PCN Title: Qualification of Additional Clip Bonding, Lead Frame Structure (Matrix) and Mold Compound, and Qualification of Additional Diodes Internal Assembly & Test Site (SSEC) for Select Discrete Products

PRODUCT CHANGE NOTICE

PCN-2588 REV1

Figure 1: Comparison of SMB Package Construction for SKY, GPP, Zener and Unidirectional TVS products

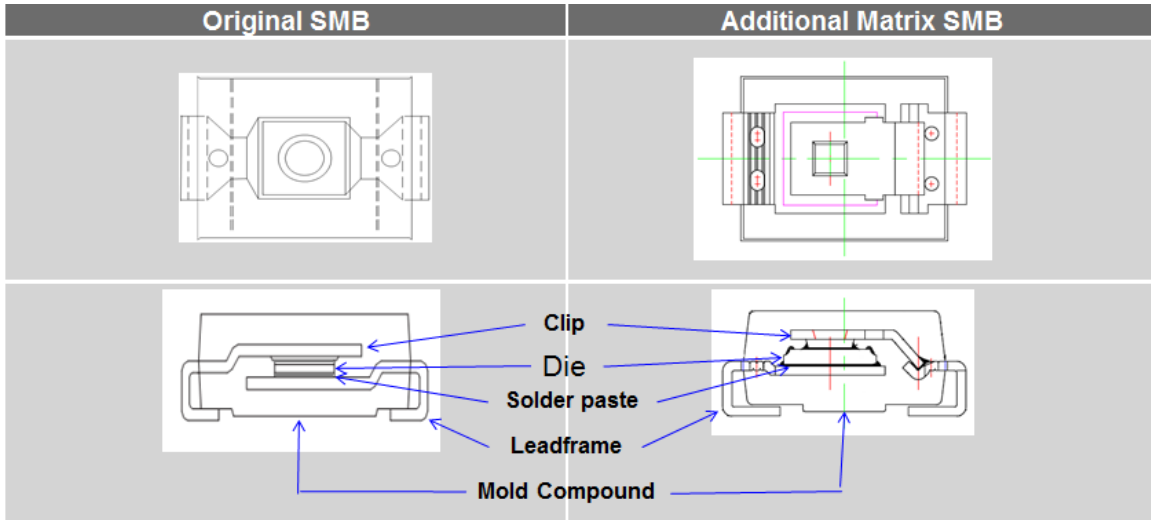
Notification Date:	Implementation Date:	Product Family:	Change Type:	PCN #:
1 June, 2022	1 September, 2022	Discrete	Clip Bond, Lead Frame, Mold Compound, Additional Assembly & Test Site	2588
TITLE				
Qualification of Additional Clip Bonding, Lead Frame Structure (Matrix) and Mold Compound, and Qualification of Additional Diodes Internal Assembly & Test Site (SSEC) for Select Discrete Products				
DESCRIPTION OF CHANGE				
<p>This PCN is being issued to notify customers that in order to assure continuity of supply and to improve assembly manufacturability, Diodes Incorporated has qualified additional clip bonding, lead frame structure (Matrix), and mold compound at Diodes subcontractor Eris Technology Corp. (ERIS) located in Taoyuan City, Taiwan for select discrete products.</p> <p>In addition, Diodes Incorporated has also qualified internal assembly and test (A/T) site (SSEC) located in Shanghai, China as an additional A/T site for select products listed below.</p> <p>Full electrical characterization and high reliability testing has been completed on representative part numbers to ensure no change to device functionality or electrical specifications in the datasheet. Refer to the attached qualification report embedded in this file (to view, download this PCN file then open it with a PDF viewer to see the attached qual report).</p> <p>There will be no change to the Form, Fit or Function of affected products unless specifically indicated (see figures 1 – 5).</p>
